ADDENDUM NO. 06

project: Rosemary Recreational Complex Contract ID: # 17PFC-131B
Needham, MA

Specifications:
131413 Swimming Pool and Spray Deck Water Features

1830/1815M
Rosemary Recreation Complex
Needham, MA
BH+A Project No. 3255

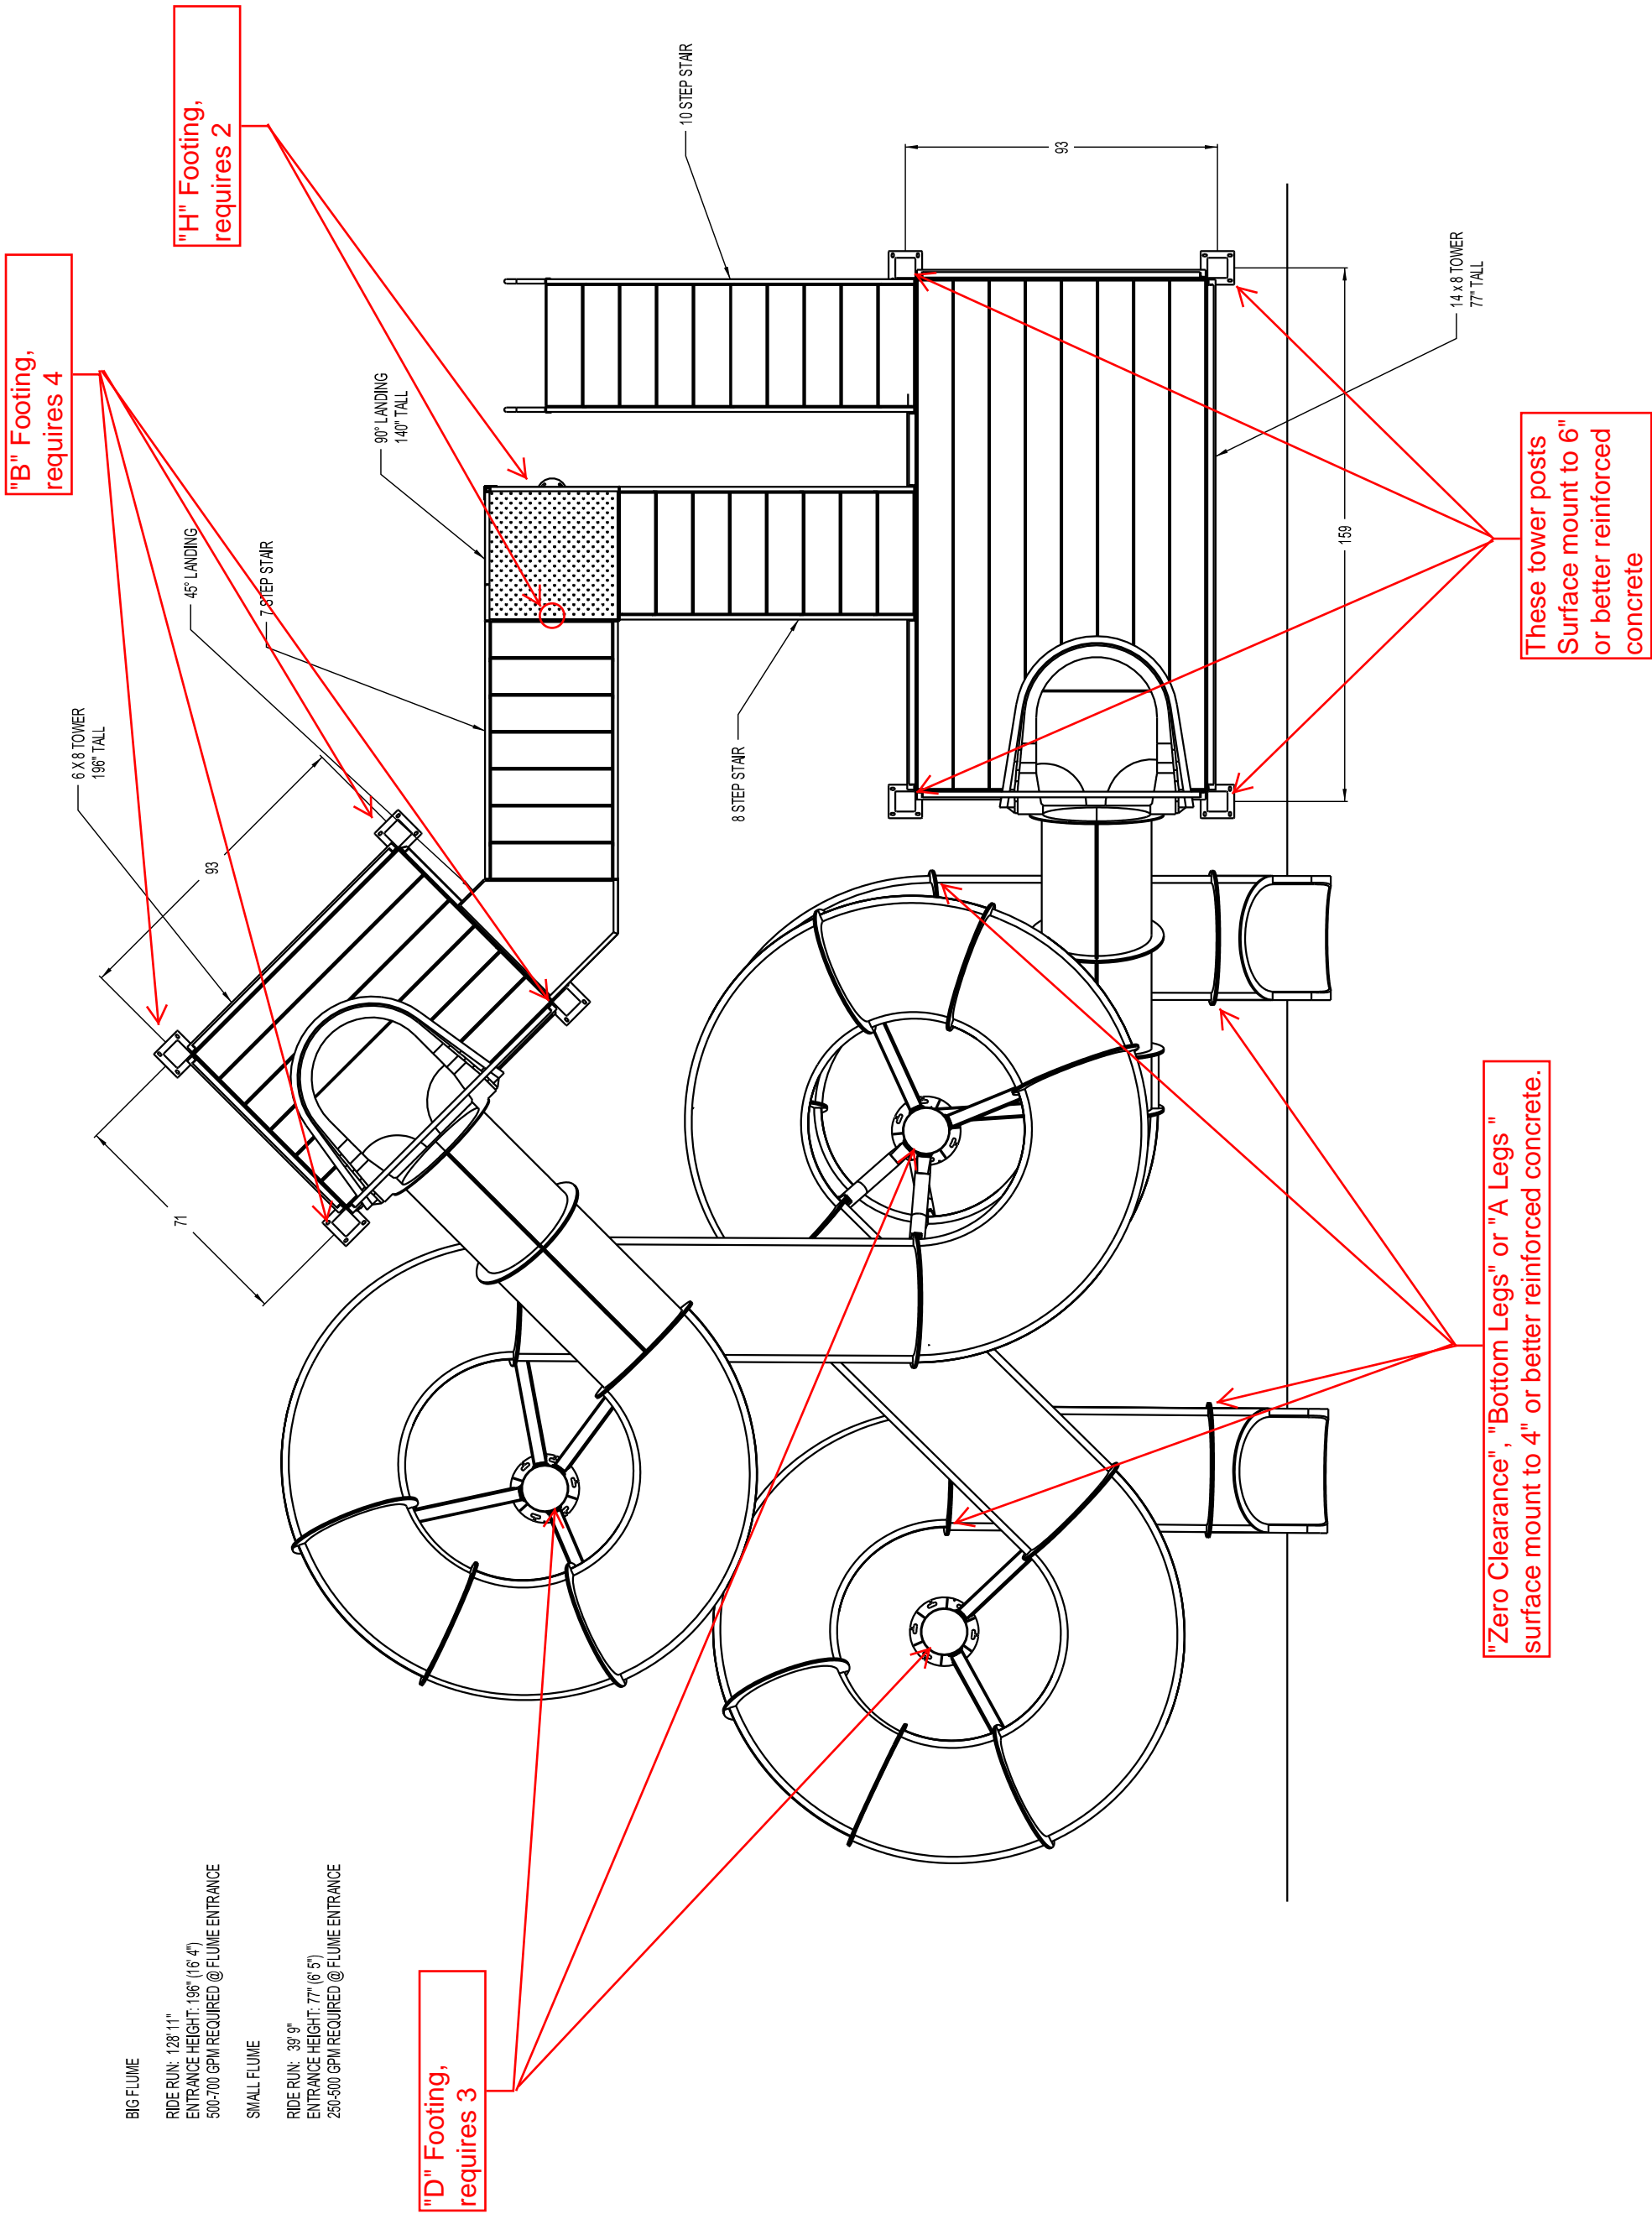
REVISION / DATE
ADDED GPM (04/04/17 M.C.)
